Development Application Accessibility Review

Hunter Sports High School

Report Prepared for: EJE Architecture
Report Prepared by: Lee-May Whong
Report Reference: AN16-206191 20160113 DAR_Hunter Sports HS_LMW
Job Number: AN16-206191
Date: 29 January 2016

DRAWING : FIRST FLOOR PLAN

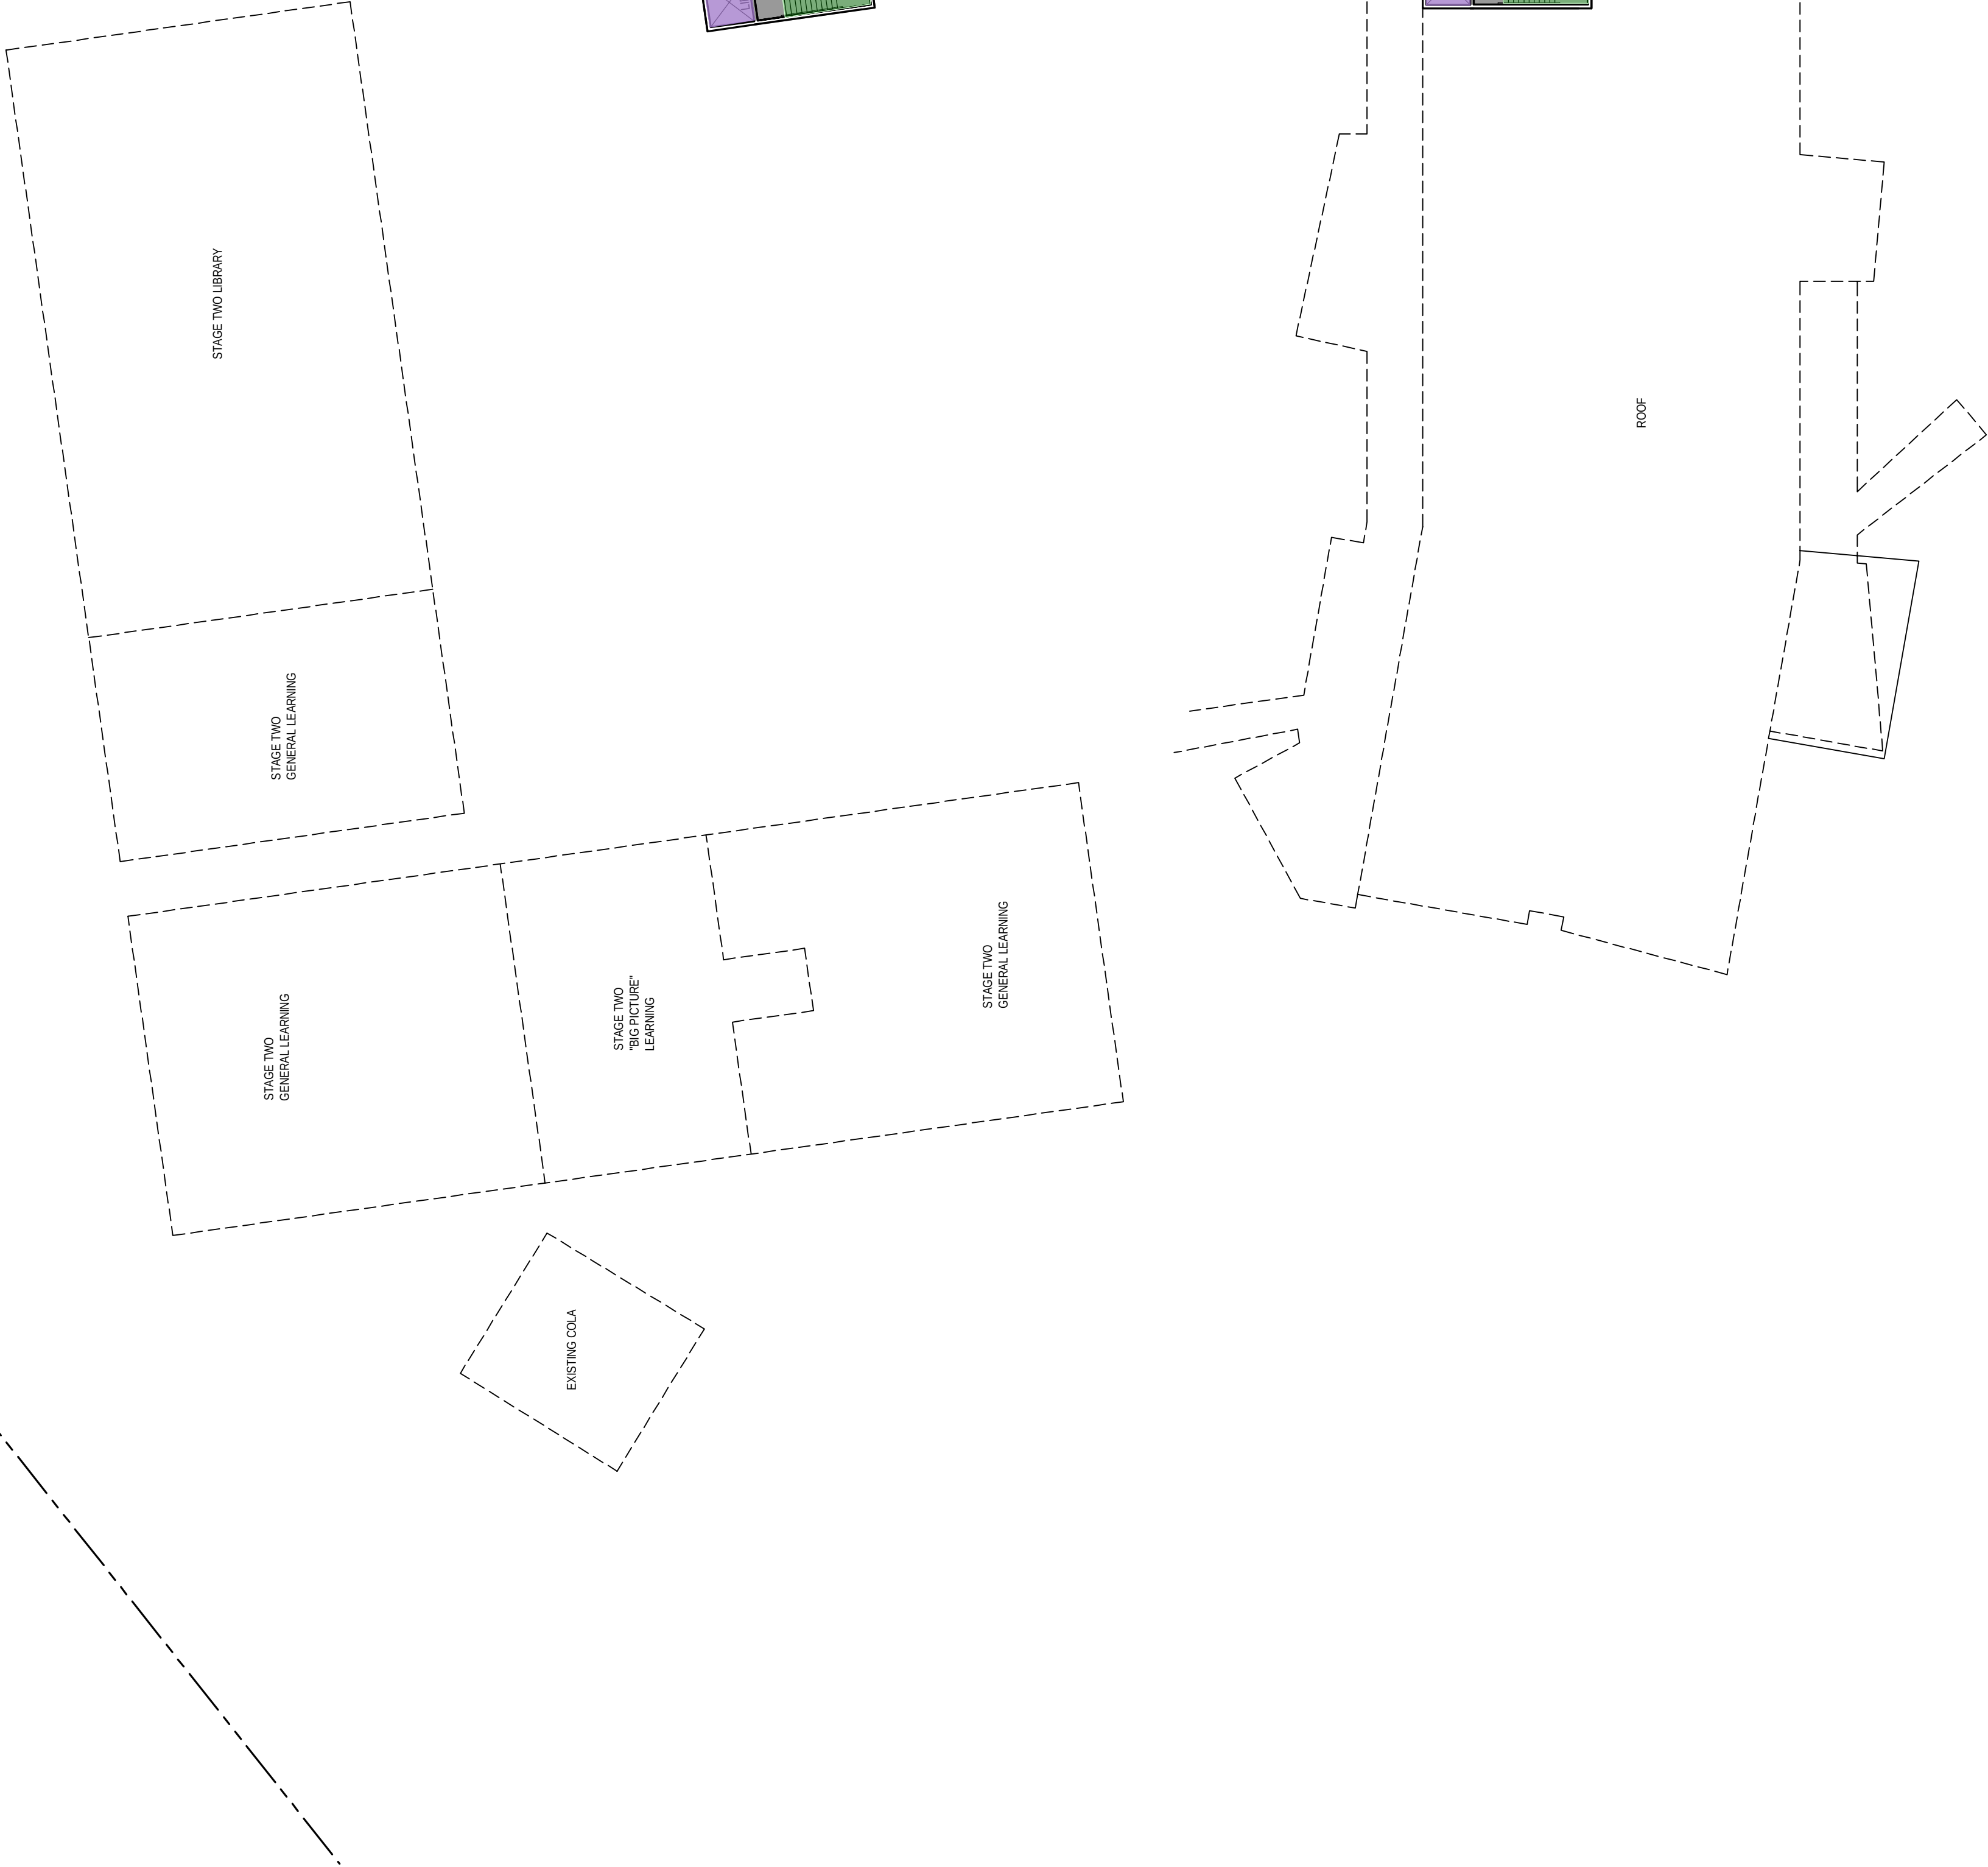
- PAD cubicles within male and female toilets to be in compliance with AS1428.1 (2009).
- Width of PAD cubicles is to be 900–920mm.
- Provide grabrails to PAD cubicles.
- Provide 900 x 900mm circulation space in front of pan and each side of doors on path to the toilet. Doors are not to swing into circulation spaces.

Frameless or fully glazed doorways and sidelights shall be clearly marked for their full width. Provide details of proposed visual indication for review, noting the following per Clause 6.6 of AS 1428.1(2009):

- Visual indication to be a solid, non-transparent, contrasting line;
- Minimum 75mm thick;
- Lower edge to be located between 900mm and 1000mm AFFL; and
- Provide 30% luminance contrast when viewed against the floor surface or surfaces within 2m of the glazing on the opposite side.
